Central Planning Authority

Agenda for a meeting of the Central Planning Authority to be held on **August 31, 2022 at 10:00am in Conference Room 1038, 1st Floor, Government Administration Building, and Elgin Avenue.**

CPA/21/22

Figure 1: LIS 2018 Aerial imagery showing application site outlined in red

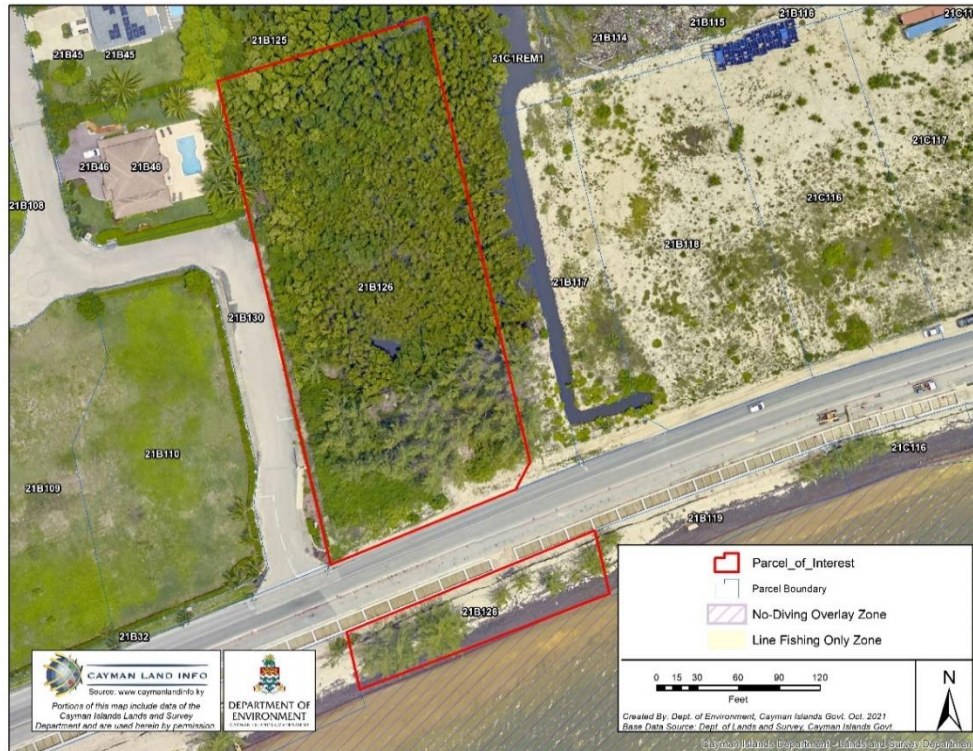
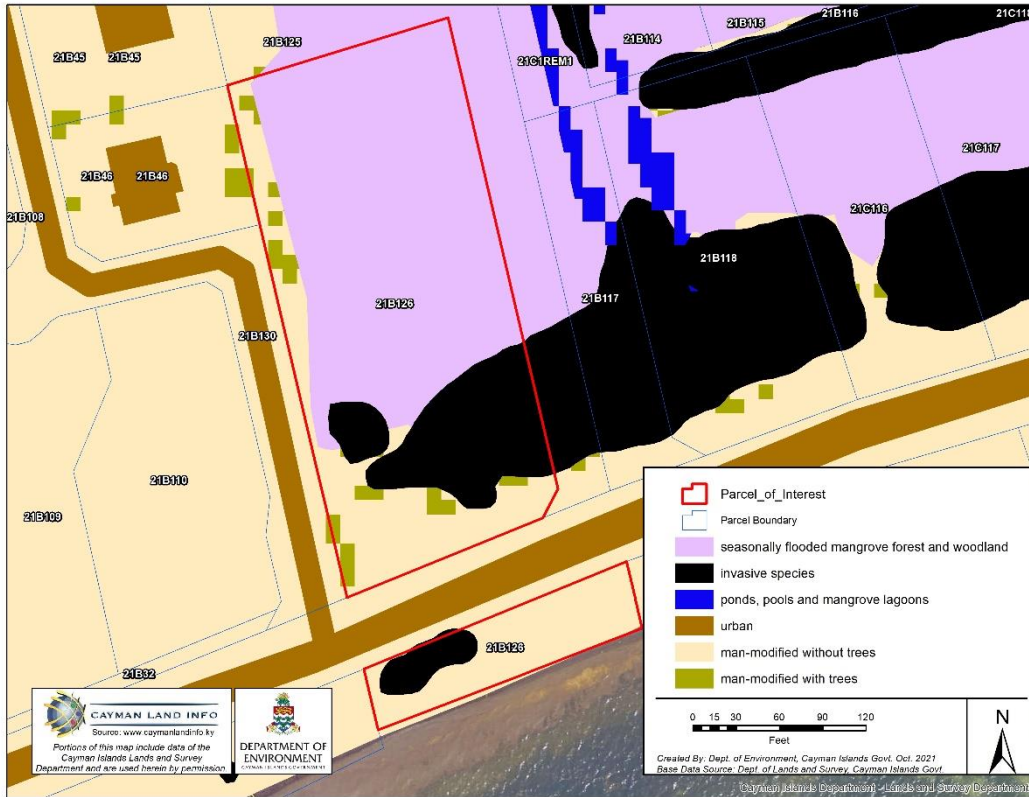
The application site is located within the South Sound drainage basin and consists of seasonally flooded mangrove forest primary habitat, as shown in Figures 1 and 2. The site has planning permission for an apartment complex (Planning Ref: P18-1054); planning permission was granted in January 2019 (CPA/02/19 item 2.5). Therefore, the application site is committed to development. Notwithstanding this, the DoE wishes to again highlight

the importance of mangrove wetlands in terms of their drainage and ecological functions. Mangroves are protected under the National Conservation Act (2013) and the Mangrove Conservation Plan (2020).

Since the proposed development will continue to fragment the South Sound drainage wetland, further reducing its ecological capacity as a storage and catchment basin for the surrounding area, it is strongly recommended that a stormwater management plan be developed. The stormwater plan should ensure that any site derived runoff is handled on-site. It is also recommended that the existing mature vegetation be retained to the greatest extent possible and incorporated into the landscaping scheme. Native vegetation is best suited for the habitat conditions of the Cayman Islands resulting in vegetation that requires less maintenance which makes it a very cost-effective choice.

Figure 2: Site Plan Overlaid onto LIS 2018 Aerial Imagery (Plan source: Velasques & Asco. Architecture Design Concepts, October 2021)

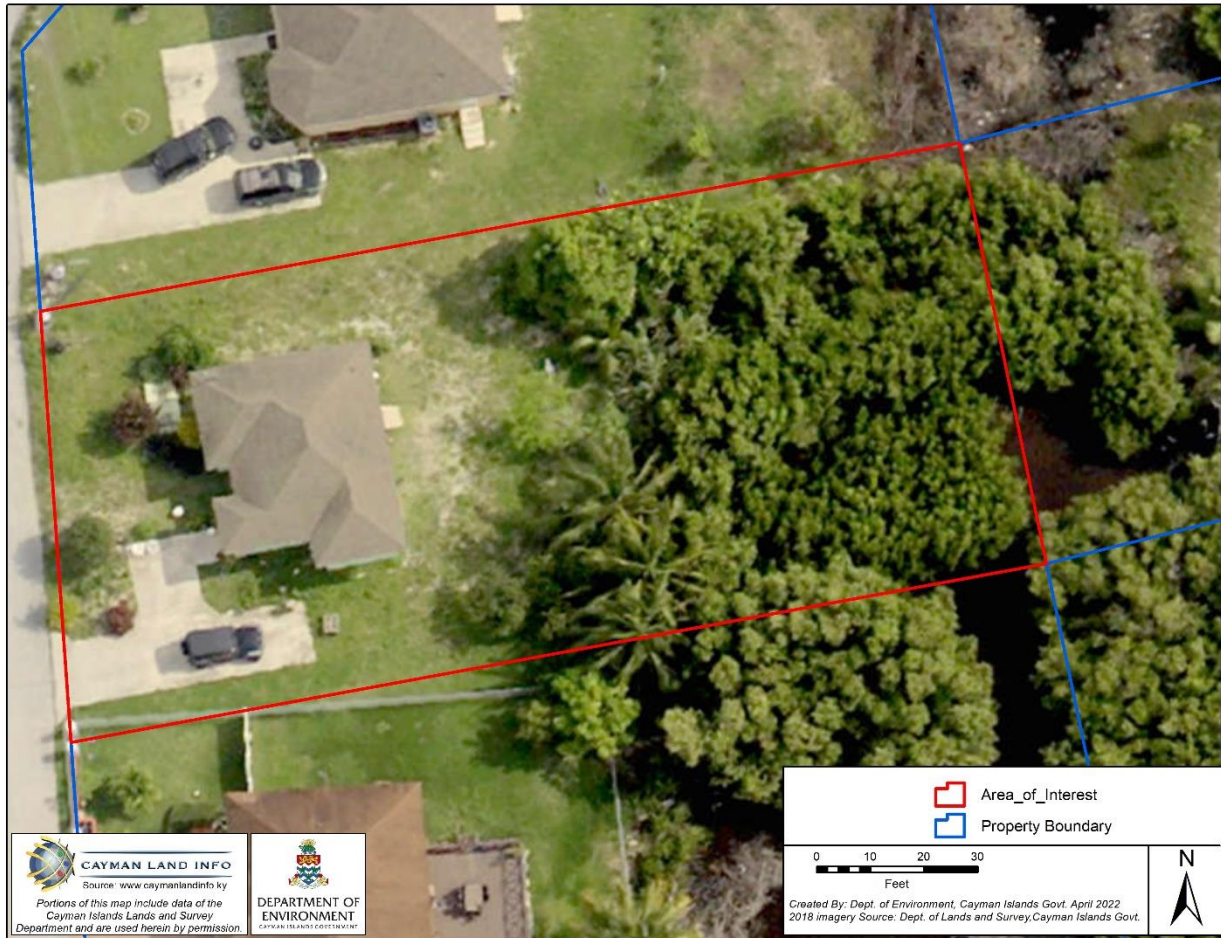
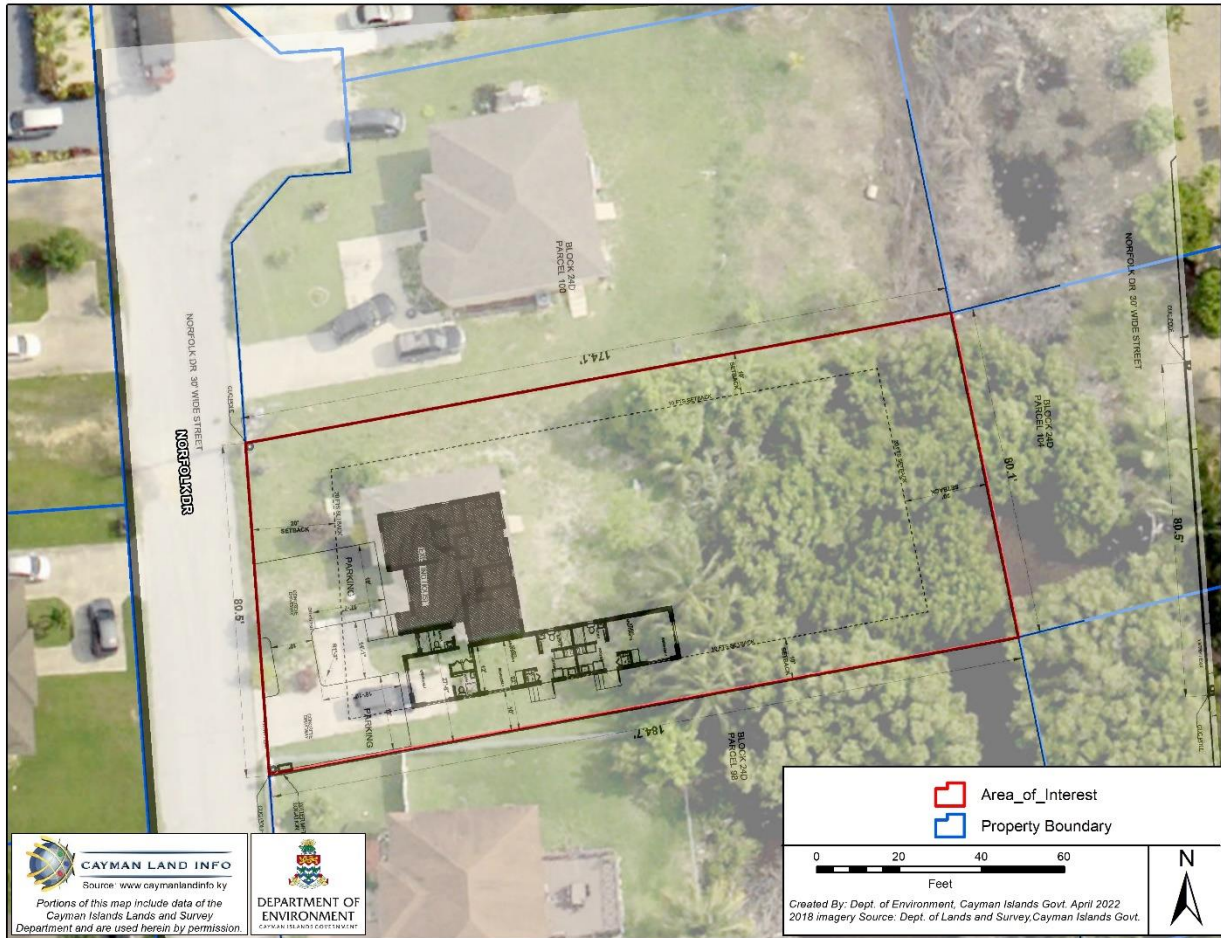
The DoE notes that the proposed addition encroaches into some of the existing vegetation on site as shown in Figure 2. However, the proposed addition is outside of the area of the existing mangrove on site. We also note that the applicant's submissions do not include the removal of the existing mangroves.

The applicant is reminded that mangroves are Schedule 1, Part 2 Protected Species under the National Conservation Act (2013) with an adopted Conservation Plan. **It is an offence to remove mangroves unless permission is explicitly sought to remove them either through the granting of planning permission or a National Conservation Council Section 20 permit.**

Figure 2: LIS 2018 aerial imagery overlaid with the applicant’s site plan. (Plan source: MJM Architecture & Design, March 2022)

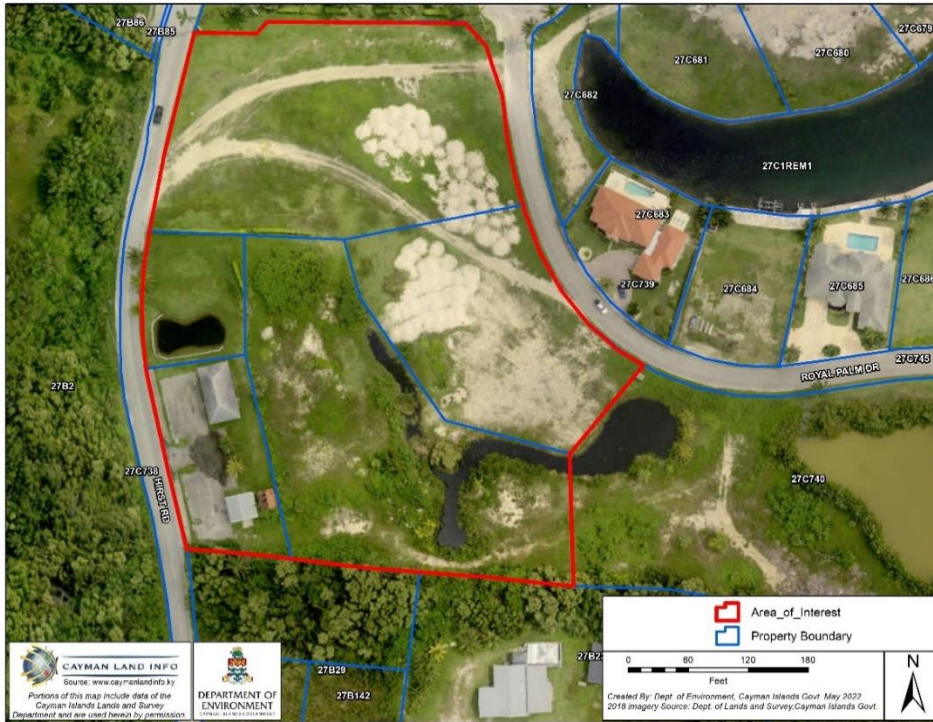
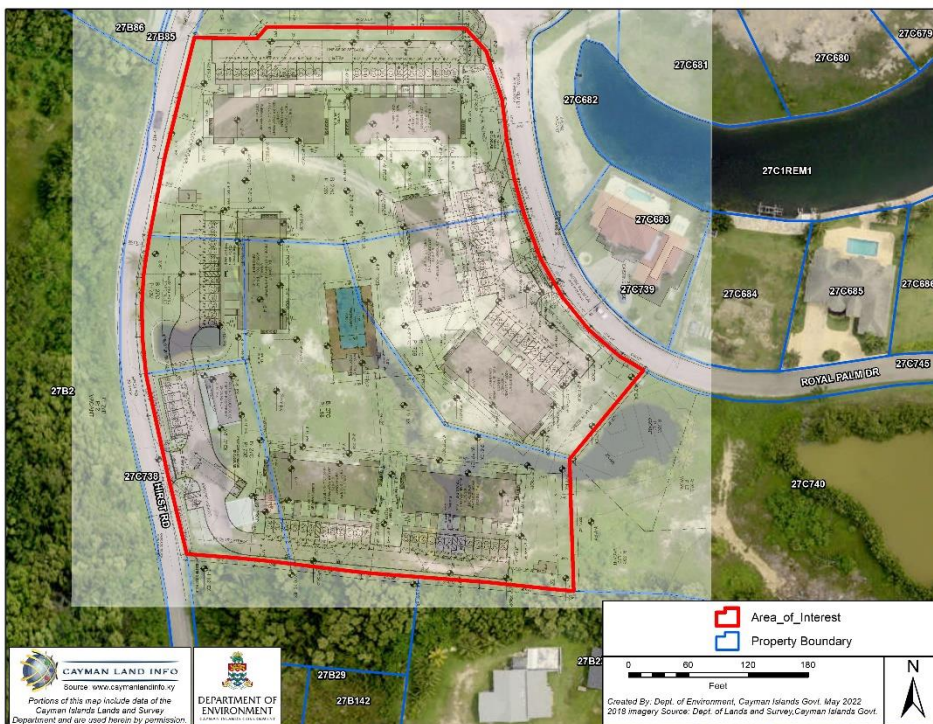
An annotation on the applicant’s site plan states that the existing pond adjacent to Building 7 is to be filled. It is also noted from the plans that the footprints of the proposed pool and Building 5 are located over a larger existing pond on-site (see Figure 2). It is unclear from the submissions whether the entirety of the pond where the pool and Building 5 are being proposed is to be filled or whether the filling will be limited to the development footprint.

The filling of the ponds will reduce the stormwater capacity of the site and surrounding area. It is therefore important that the stormwater plan for the development is designed in a manner that manages stormwater on-site so that it does not impact the surrounding areas including the road. The applicant may wish to consider the use of porous surfaces in the areas of hardstanding e.g. car parks, to allow rainwater infiltration and to help manage the impacts of stormwater run-off.
